URGENT: MEDICAL DEVICE CORRECTIVE ACTION - UPDATE**SINGLE USE LIGATING DEVICE**

Product Name	Model/Catalog Number	Manufactured Date Range	UDI
SINGLE USE LIGATING DEVICE POLYLOOP	HX-400U-30	22-Sept-2022- 19-March-2026	04953170368615

Date: 20-April -2026

Attachment 1 - SINGLE USE LIGATING DEVICE HX-400U-30
Preventing Incorrect and Incomplete Loop Detachment

Figure 1

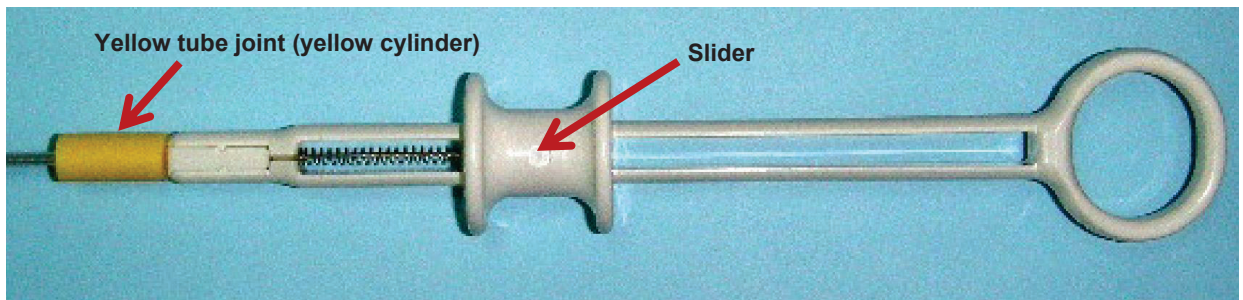
- Inadvertent or intentional movement of the yellow tube joint (cylinder) away from the device handle during use. Intentionally moving the yellow tube joint away from the handle to prematurely tighten the loop during use may cause the inability to release the ligation loop. (See figure 1 below.)
- Forceful advancement of the slider located on the device handle when resistance is encountered may cause an inability to release the loop.

■ **Do not hold the loop with the distal end of the tube sheath while the loop is surrounding the tissue. (refer to page 5 in the manual)**

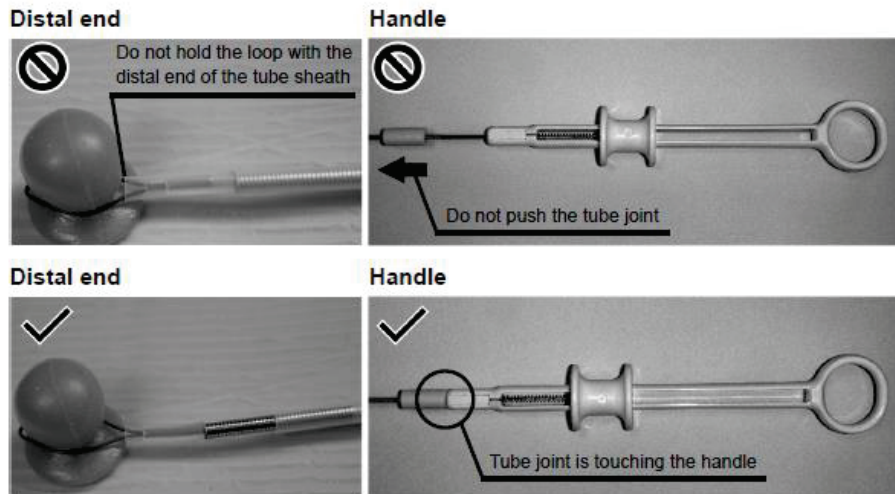
Otherwise, when the tissue is ligated, the loop may be detached from the hook in the tube sheath and tangled with the hook.

- **Do not remove the loop from the hook while the coil sheath is not extended from the tube sheath. (refer to page 6 in the manual)**

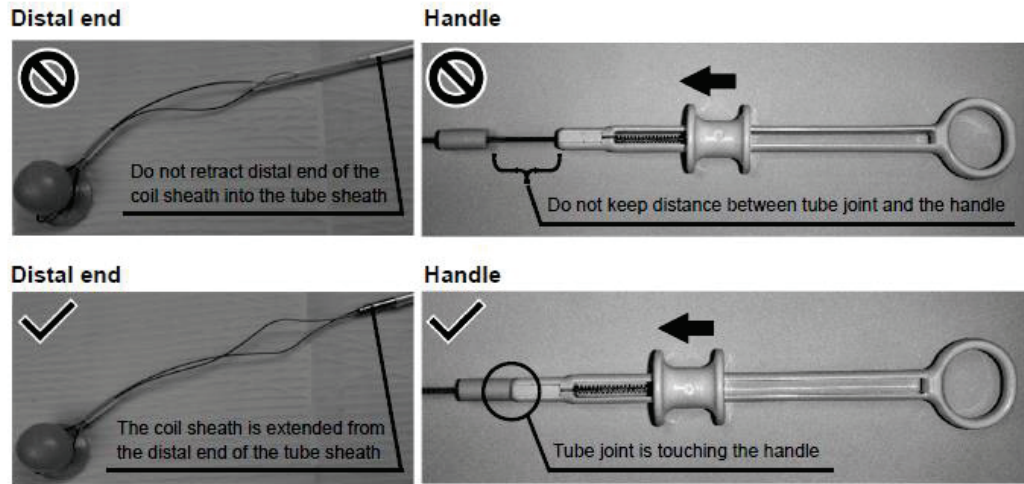
Otherwise, the loop may be tangled with the hook and become impossible to be removed.

- **With the proximal end of the tube sheath and handle kept straight against the biopsy valve of the endoscope, push the slider when detaching the loop. (refer to page 6 in the manual)**

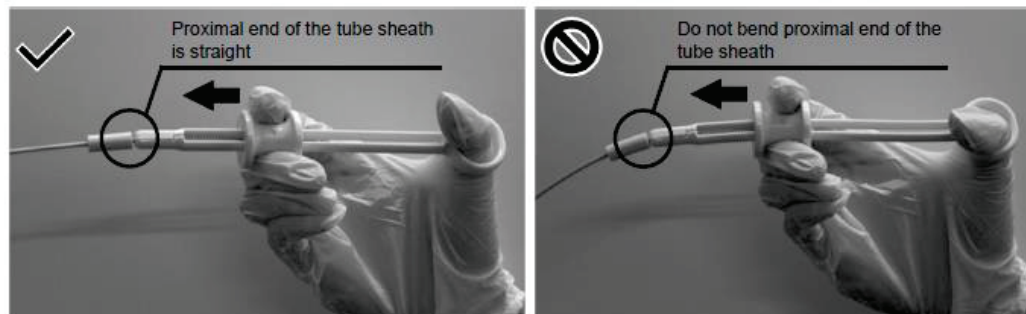
Bending the proximal end of the tube sheath will increase frictional resistance, which may damage the handle when pushing the slider.
